## Landscape Referral Response

<b>Application Number:</b>	DA2025/0022
<b>Date:</b>	07/02/2025
<b>Proposed Development:</b>	Demolition works and construction of a five (5) storey residential flat building with basement parking and associated landscaping
<b>Responsible Officer:</b>	Maxwell Duncan
<b>Land to be developed (Address):</b>	Lot CP SP 4518 , 101 North Steyne MANLY NSW 2095

Fig.1 Soft landscape setbacks between the front boundary and the terraces and spa. Extract from Ground Floor Plan.

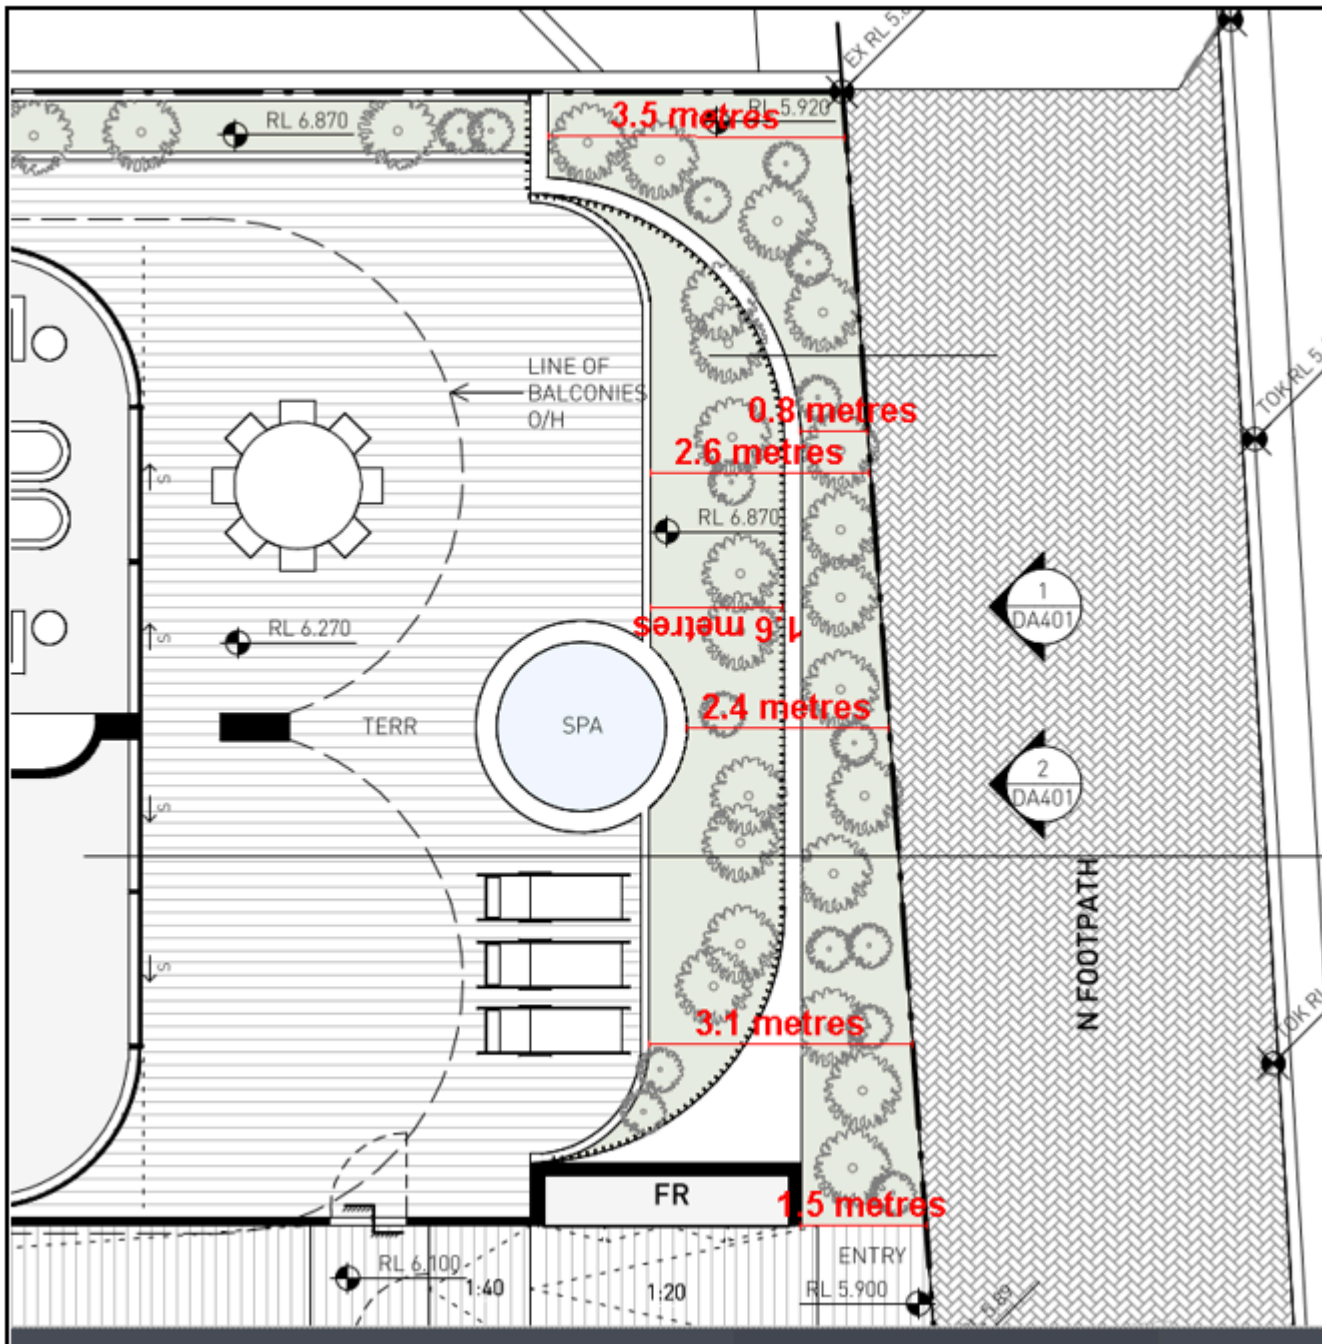
It is noted that the plans propose a spa at ground level located some 2.4m in from the front boundary. Garden beds ranging between 800mm and 3m in width are proposed between the decked terraces and the street. (Figs 1 and 2 below).

From a landscape perspective, the proposed species are considered viable in the locations provided. If additional soft landscape is required, planters could be extended over the basement and further into the terraces. The adequacy of the soft landscape areas provided in terms of the overall building design is left to planning and urban design consideration.
